Access Compliance Report

Public Rights-of-Way

(Curb Ramps)

Intersection ID: 15045	Main Street: FAIRWOOD_AV	Cross Street: S_TRYON_ST	Location: W
ADA ID: 5E0C888F868A	Ramp Type: PerpDiag	Initial Pass/Fail: Fail	Overall Compliance: No
Severity Score: 13.75			
Codes/Mitigation Info/Possible Solution		Field Measurements/Component Compliance

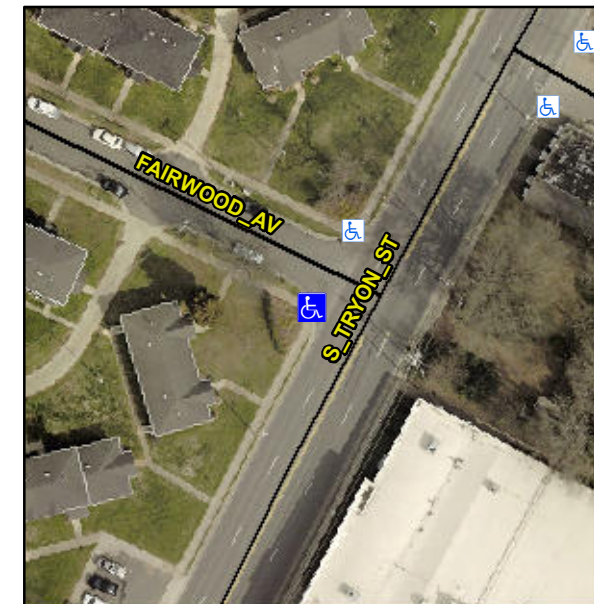
R304.2.2, R304.5.3

Compliance	Description	Data	Compliance	Description	Data
N/A	Ramp Length (in)	60.5	No	Ramp Slope (%)	9.8
Yes	Ramp Width (in)	48.0	No	Ramp XSlope (%)	3.4
N/A	Flare Type LT	N/A	N/A	Flare Type RT	N/A
N/A	Flare Slope LT (%)	N/A	N/A	Flare Slope RT (%)	N/A
N/A	Flare Traversable LT?	N/A	N/A	Flare Traversable RT?	N/A
N/A	Landing Length (in)	N/A	N/A	DWS Provided?	N/A
N/A	Landing Width (in)	N/A	N/A	DWS Contrast?	N/A
N/A	Landing Slope (%)	N/A	N/A	DWS Length (in)	N/A
N/A	Landing X Slope (%)	N/A	N/A	DWS Full Width?	N/A
N/A	Landing Curb? (Y/N)	N/A	N/A	DWS Offset (in)	N/A
N/A	Shared Landing?	N/A			
N/A	Gutter Ponding?	N/A	N/A	Gutter Slope (%)	N/A
N/A	Gutter Lip Ht (in)	N/A	N/A	Gutter X Slope (%)	N/A
N/A	Painted X Walk1?	No	N/A	Painted X Walk2?	No
	X Walk 1 Direction	To NW		X Walk 2 Direction	To SW
N/A	X Walk 1 Width (in)	N/A	N/A	X Walk 2 Width (in)	N/A
	X Walk 1 Slope (%)	3.9		X Walk 2 Slope (%)	1.9
	X Walk 1 X Slope (%)	2.7		X Walk 2 X Slope (%)	6.5

Remove & Replace Curb Ramp With Two New Directional Ramps or Equivalent.
